Browns Ferry Nuclear Plant, Units 1, 2, and 3
Renewed Facility Operating License Nos. DPR-33, DPR-52, and DPR-68
NRC Docket Nos. 50-259, 50-260, and 50-296

Subject: **Proposed Technical Specifications (TS) Change TS-505 - Request for License Amendments - Extended Power Uprate (EPU) - Supplement 22, Responses to Requests for Additional Information**

**Responses to NRC Requests for Additional Information
SCVB-RAIs 2, 3, 4, 5, 6, 7, 9, 10, 11, 12, 13, 15, 16, 17, 18, 19, 20, 21, 22, 23, 27, 28, 29, 31, and 33**

Figure SCVB-RAI 2-1
Comparison of EPU Short-Term Recirculation Suction Line Break DBA-LOCA Containment
Pressure Responses
(Design Condition: Initial DW Temperature =70°F)
The case identified by the solid curve is the same case in Reference 1, Figure 2.6-7.

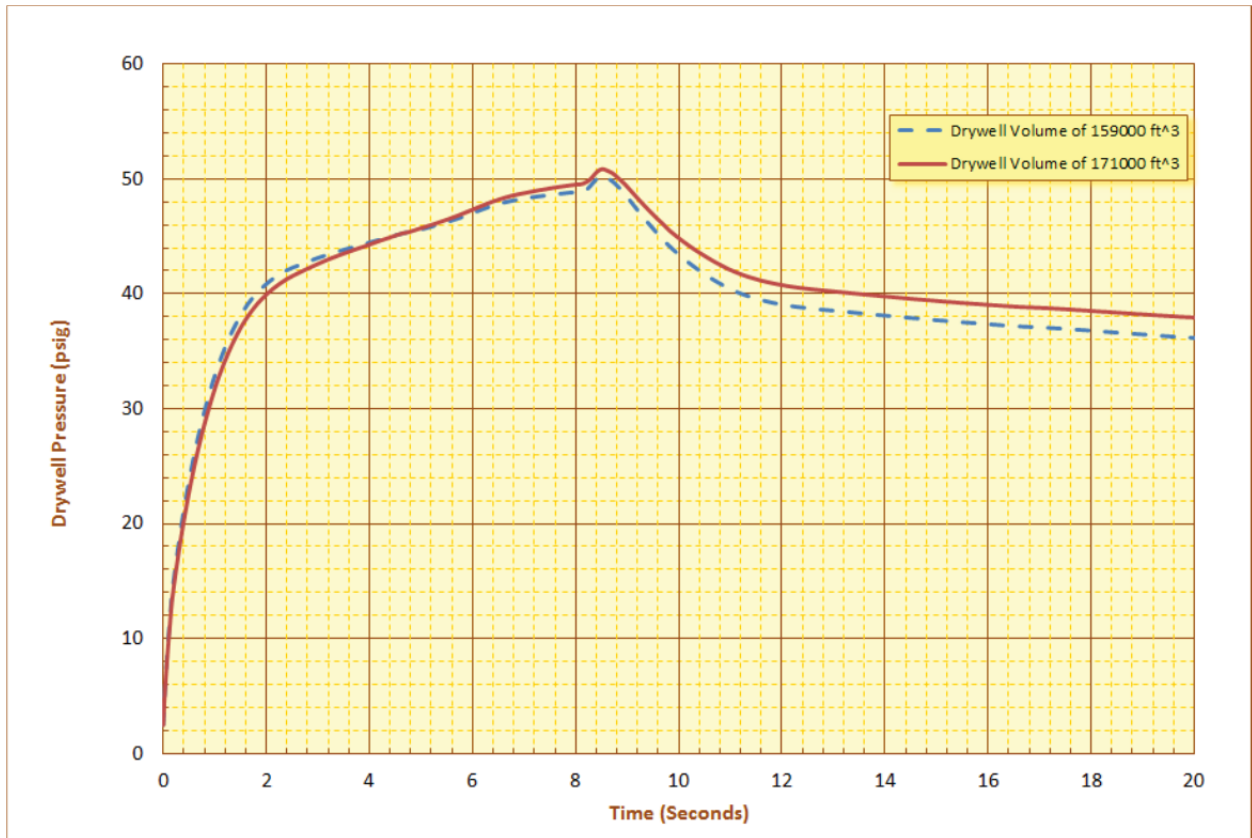
The above statement provides a qualitative justification for a higher drywell pressure response for a larger drywell volume. For the short term drywell pressure response, it would seem that using the larger drywell volume of 171,000 ft³ would result in a less limiting pressure response than using the minimum volume of 159,000 ft³. Confirm that maximum drywell and wetwell pressure response mentioned above (using the larger drywell volume of 171,000 ft³) was obtained by a sensitivity analysis performed using the LAMB and M3CPT computer codes for drywell volumes of 171,000 ft³ and 159,000 ft³ using same assumptions and same remaining input parameters.

In response to this RAI, a sensitivity run was made for the design case in Table 2.6-1 of Reference 1 (PUSAR) by changing only the initial drywell volume from 171,000 ft³ to 159,000 ft³. The comparison of drywell pressures for those two cases is shown in Figure SCVB-RAI 2-1, which is consistent with the discussion given above. For the case at design conditions in Table 2.6-1, the initial drywell volume is 171,000 ft³ and the peak DW pressure is 50.9 psig. The peak DW pressure is 50.3 psig with a smaller drywell initial volume of 159,000 ft³.

Figure SCVB-RAI 16-1: CLTP/EPU LOCA DW TEMP Starting at 150°F

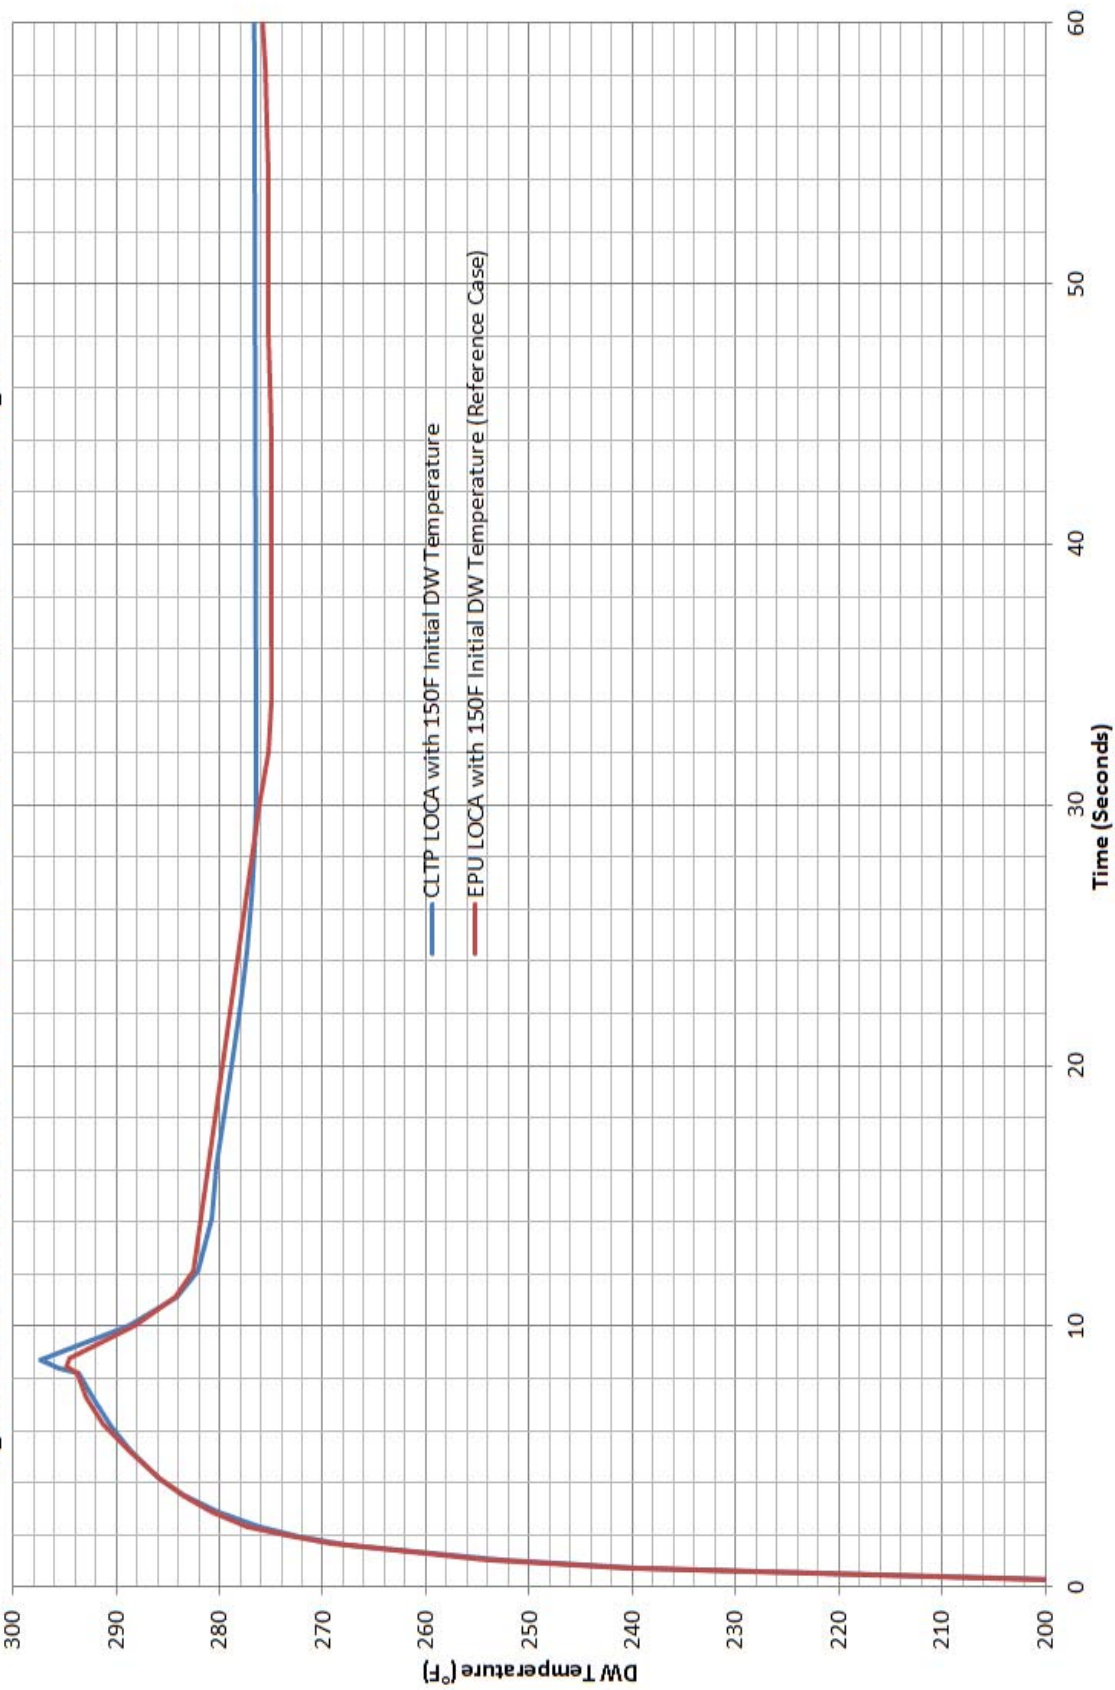
In the current response to GL 96-06, what are the drywell gas and the RBCCW temperatures used in the analysis to determine the boiling time of 61 seconds in the drywell cooling coils? State the basis for these temperatures and confirm that the both are limiting for the boiling time of 61 seconds in the RBCCW piping and the drywell cooler cooling coils. Provide the same temperature under the EPU conditions with justification that these are most limiting for the boiling time determination in the drywell cooling coils.

3) Figure SCVB-RAI 16-1 shows the drywell temperature profiles for a DBA-LOCA with an initial drywell temperature of 150°F for both CLTP and EPU conditions. In comparing the drywell temperature profiles, the discussion is separated into the following three time periods:

Based on the minor differences in the drywell temperature profiles and the margin between the RBCCW pump start (40 seconds) and calculated time to boil (61 seconds), it is concluded that voiding would not occur under EPU conditions prior to the restart of the RBCCW pump.

Figure SCVB-RAI 17-1
Clean Demineralizer System
(Typical of Units 2 and 3)

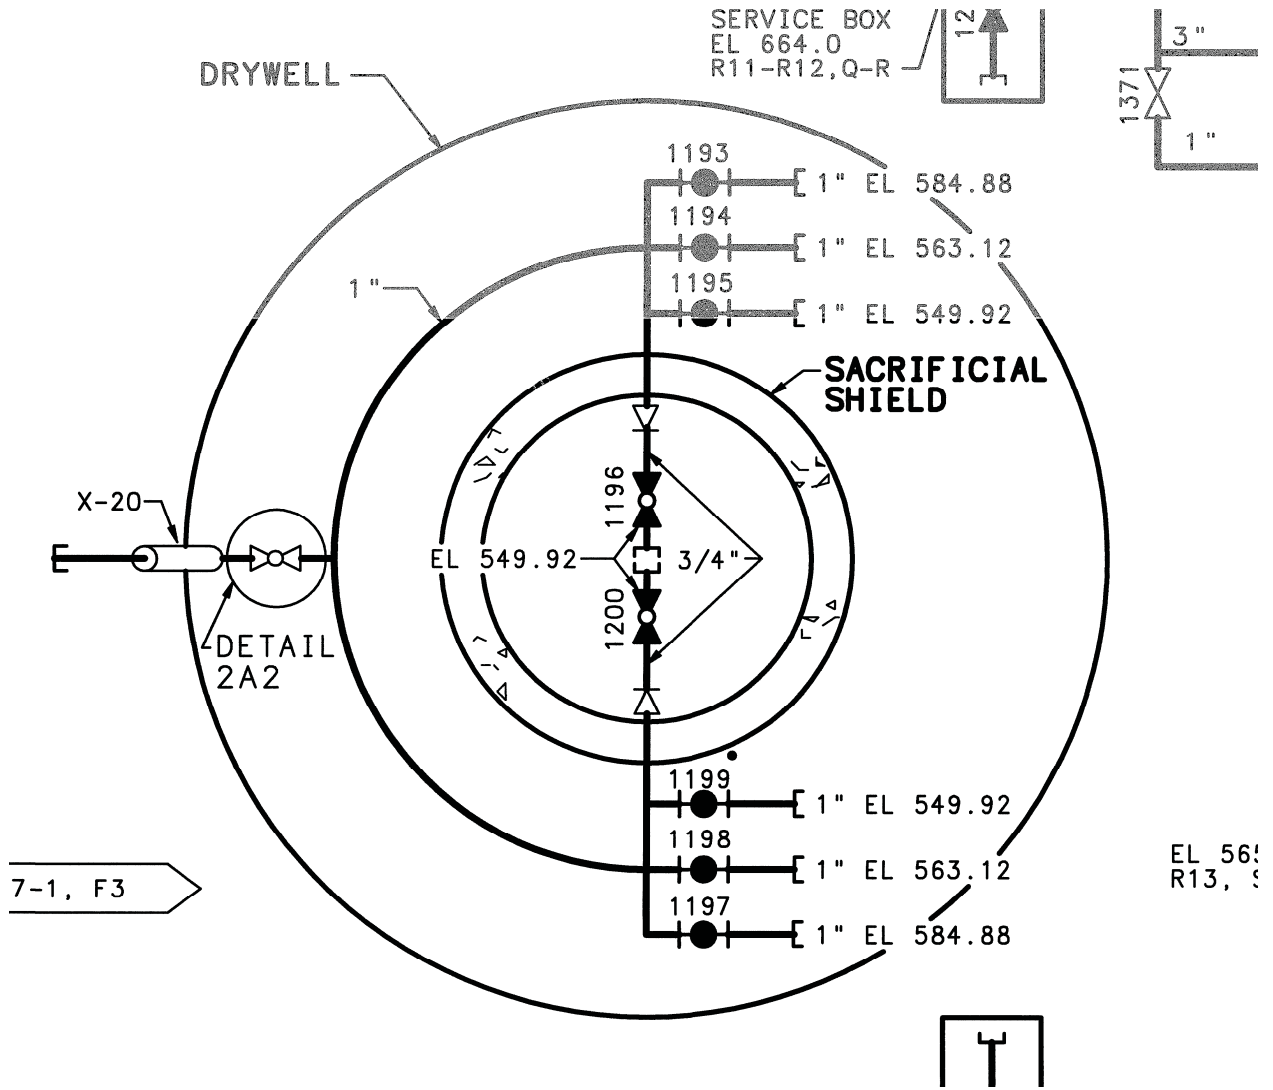
Section 2.6.1.5 of PUSAR provides the current and proposed responses to GL 96-06 for the demineralized water system, drywell floor drain sump discharge, drywell equipment drain sump discharge, and reactor water sampling system. For these systems, provide the penetration numbers in the UFSAR Table 5.2-2 for the piping between which containment isolation valves are under consideration for GL 96-06.

- 1) The penetration for the Demineralized Water System is X-20 on all three units. (See Figure SCVB-RAI 17-1.)
 - a) Unit 1 - The demineralized water penetration was cut and capped by a modification and some of the piping inside the drywell has been removed. The possibility for pressurization due to heat-up of trapped water in the piping no longer exists for this line on Unit 1.
